SOUTH CENTRAL WATERFRONT COMBINING DISTRICT & DENSITY BONUS PROGRAM (DRAFT – Staff Recommendations)

PLANNING DEPARTMENT
CITY OF AUSTIN

Figure 3.2: SCW Subdistrict and Floor-to-Area Ratio Map

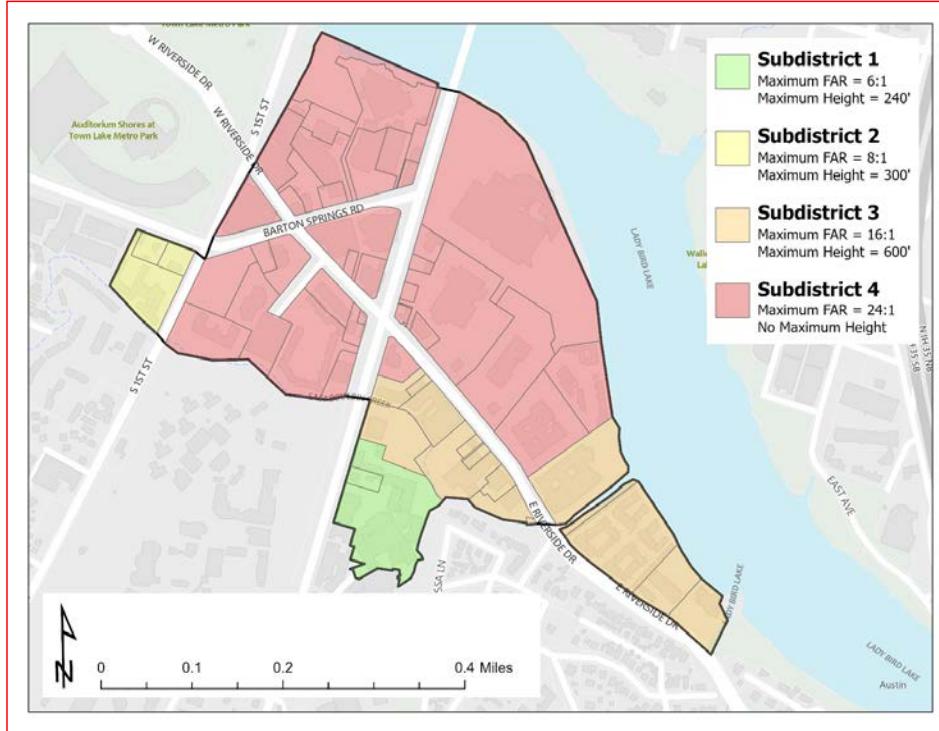
Commented [MS1]: Planning Commission Recommendation: Remove Subdistrict 1 and renumber:

Subdistrict 1:

The lowest density subdistrict, Subdistrict 1 serves as a transitional buffer between existing low density residential to the east and the subsequent low medium density of Subdistrict

The boundaries of Subdistrict 1 shall apply to the portions of property no less than 250 feet from the public right of way along South Congress Avenue.

- a. The maximum floor to area ratio is 3:1.
- b. The maximum building height is 120 feet.

Figure 4.2: Internal Circulation Route Option 2 Cross Section

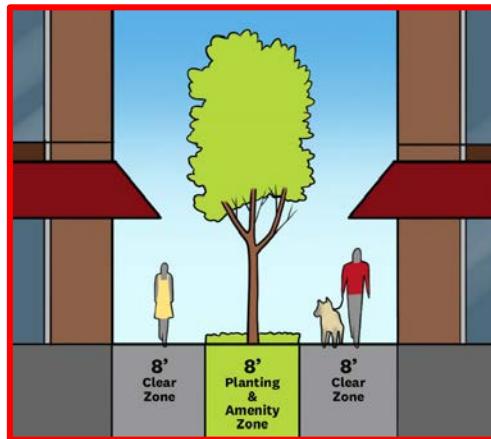
Commented [MS3]: Planning Commission
Recommendation: REMOVE- "All internal circulation routes as described in [Section 3.5.1 \(Density Distribution Areas\)](#) must have a minimum 15-foot width with either:"

Commented [MS5]: Planning Commission
Recommendation: Increase from 10-foot to 15-foot.

Commented [MS7]: Staff recommendation for shade trees.

Figure 4.3: Internal Circulation Route Option 3 Cross Section

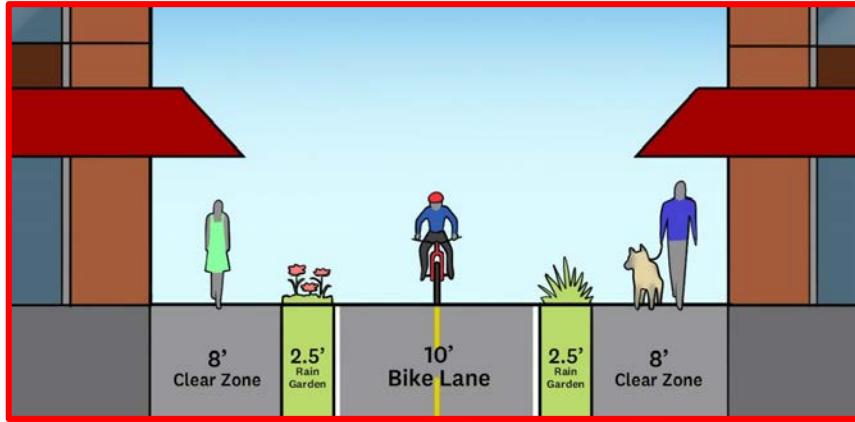
Commented [MS8]: Planning Commission
Recommendation: Expand the clear zone from 5 to 7.5 feet on each side. This recommendation was increased to 8 feet to comply with the Americans with Disabilities Act.

Commented [MS9]: Staff recommends change to rain garden(s) from planting zone(s).

Figure 4.4: Internal Circulation Route Option 4 Cross Section

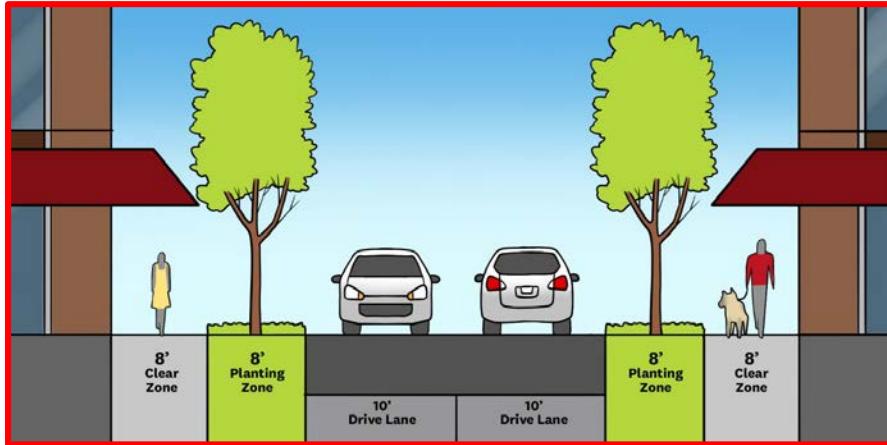
Commented [MS10]: Staff recommendation for shade trees.
